ADDENDUM No. 1

Title: PRTC Fuel Storage Tanks and Dispensers Replacement

3. ATTACHMENT A-5 SITE PLAN – Fuel Tank Replacement Plan

Providing Revised Sheets (C201 and C400) for Fuel Tank Replacement Plan by IMEG

C201

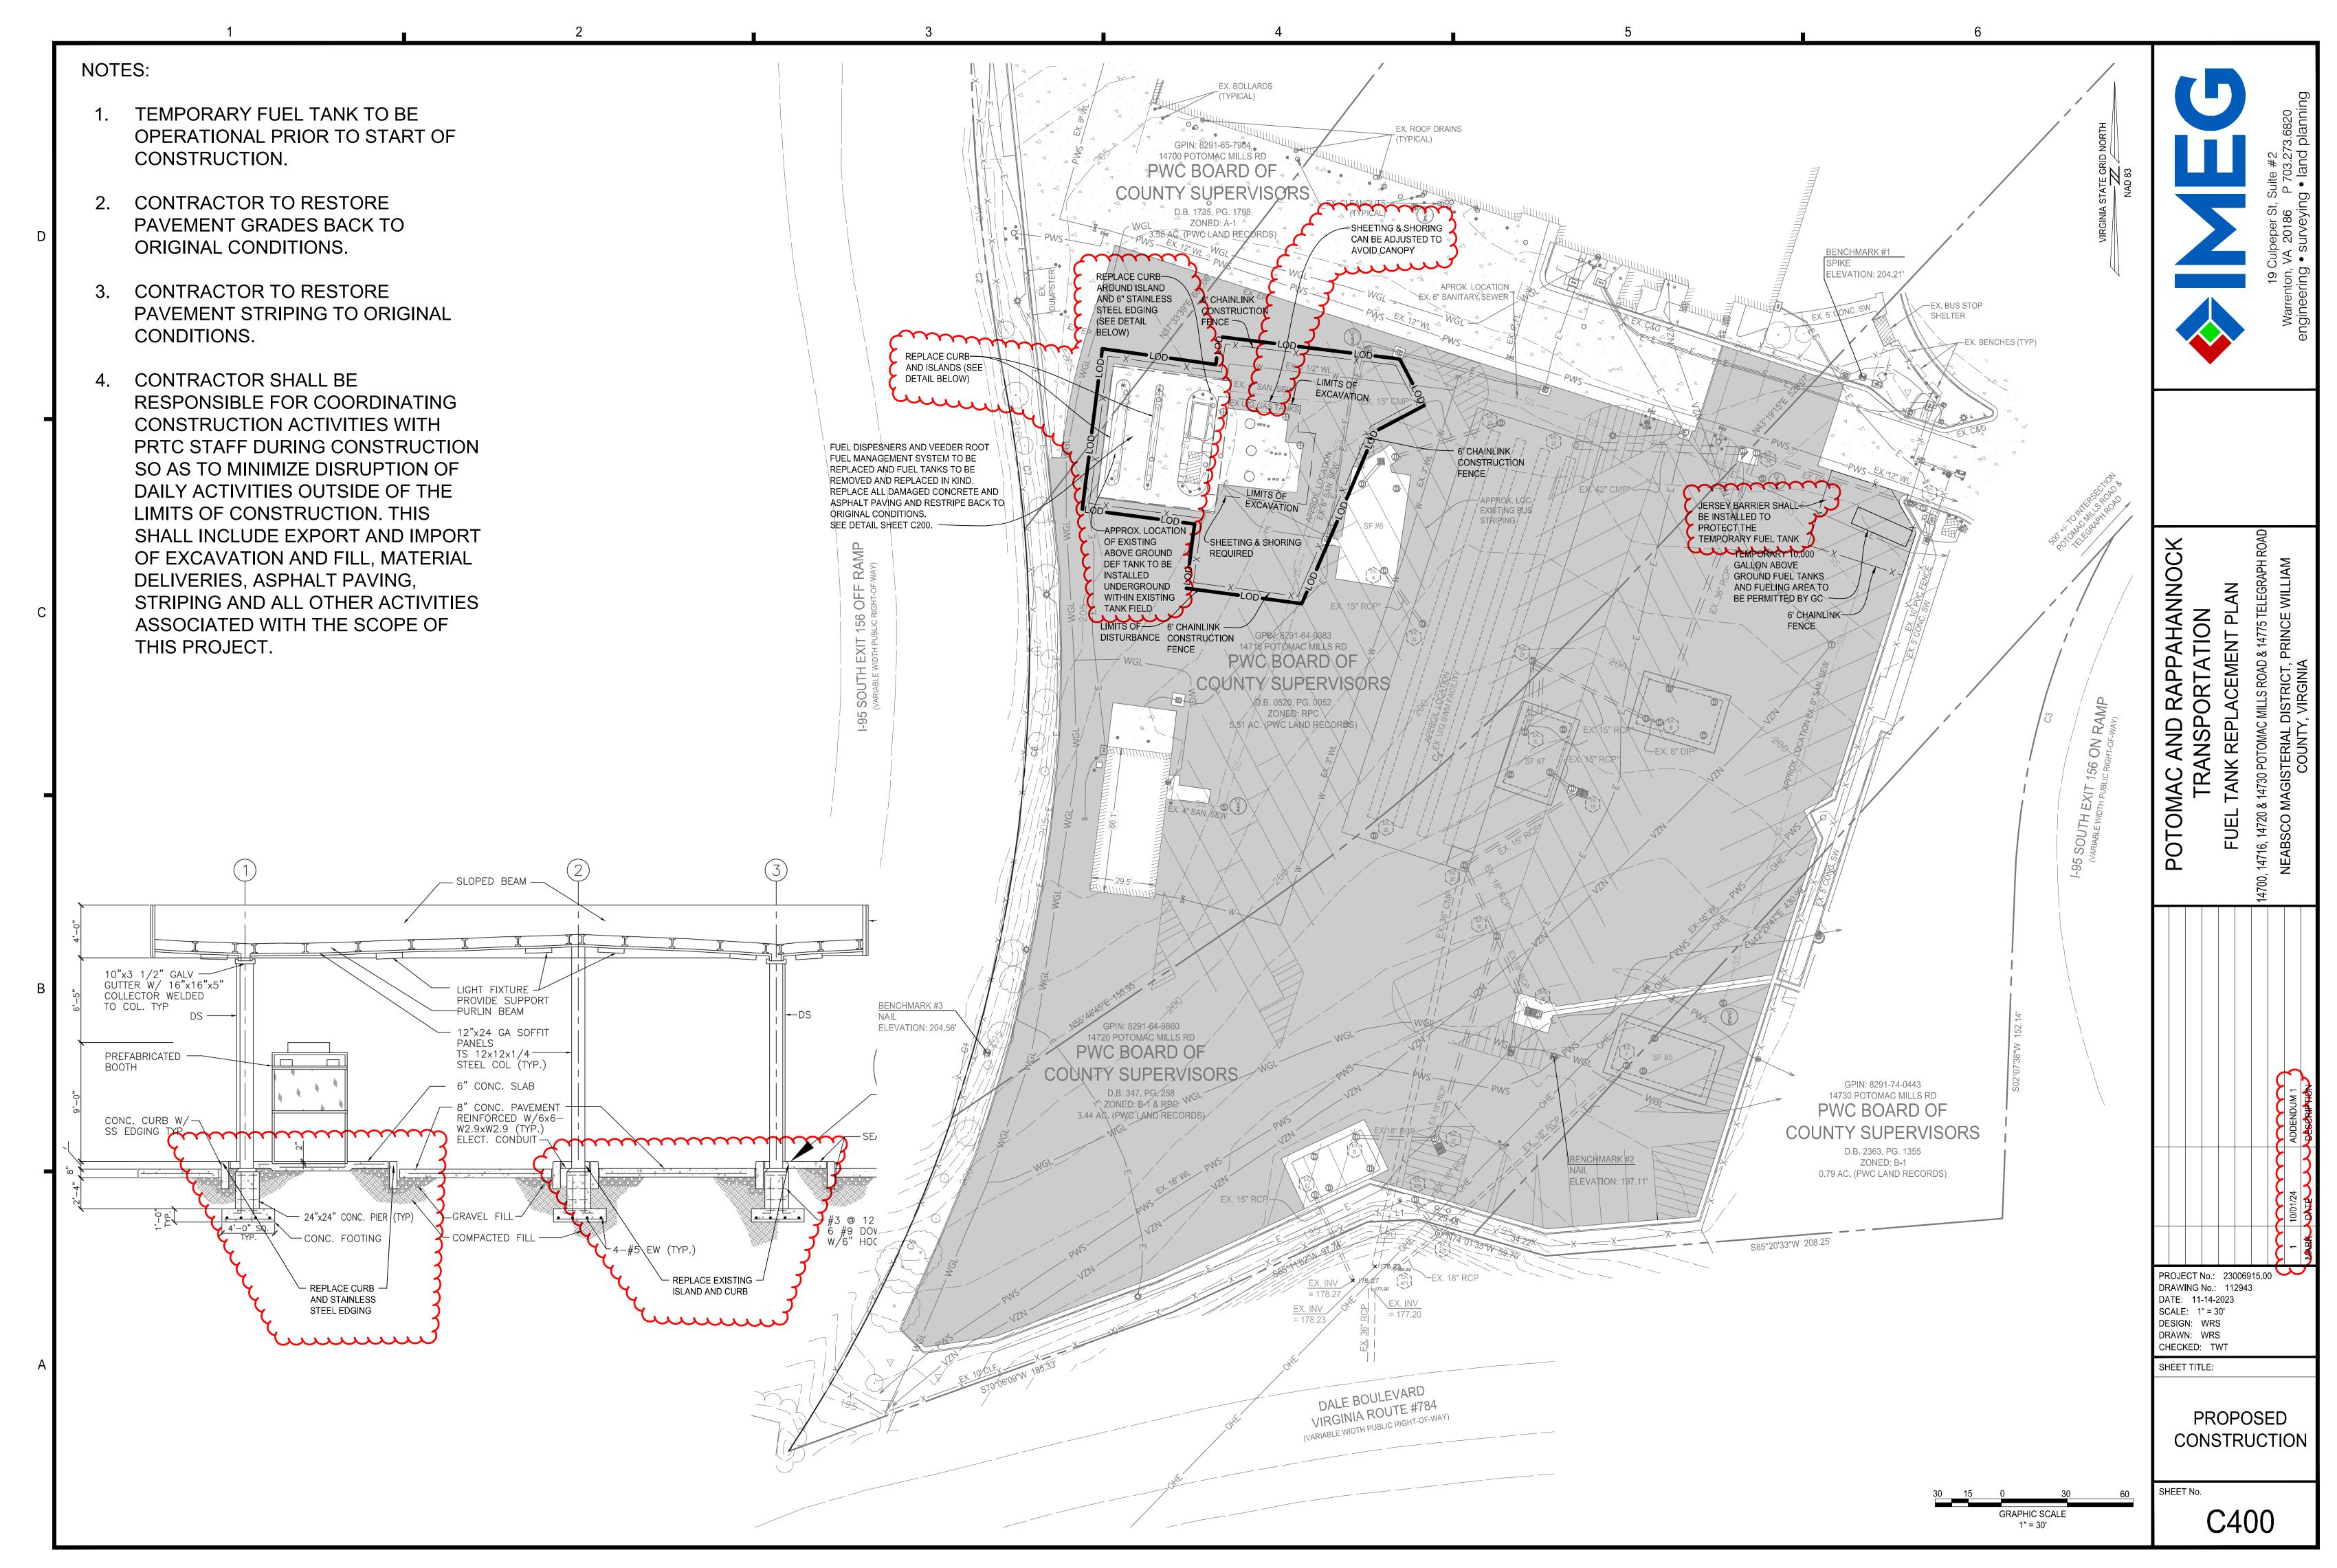
35. Drawing C201 shows new USTs will be eight feet in diameter. The existing diesel USTs are ten feet in diameter according to the other drawings. Using the current orientation for installing the new eight-foot diameter diesel tanks would require the excavation area to be longer in length and outside the footprint of the proposed "limits of excavation". Are we to provide new eight-foot diameter or ten- foot diameter diesel USTs?	September 24, 2024/Tanks Direct	The new USTs shall be 10 feet diameter. Please see revised Sheet C201.

Question/Clarification	Date Submitted/ Prospective Bidder	Response		
44. Are we installing the new Veeder-Root TLS-450 in the same location as the old Veeder-Root TLS-350?	September 24, 2024/Tanks Direct	New Vedeer-Root TLS-450 shall be installed per the technical specifications on Sheet C201.

46. Is there an existing remote alarm connected to the existing Veeder-Root TLS-350?	September 24, 2024/Tanks Direct	No.		
47. Are we replacing and/or installing a new Veeder-Root remote alarm for the new Veeder-Root TLS-450?	September 24, 2024/Tanks Direct	Yes, the new Vedeer-Root TLS-450 with new remote alarm shall be installed as shown on Sheet C201.
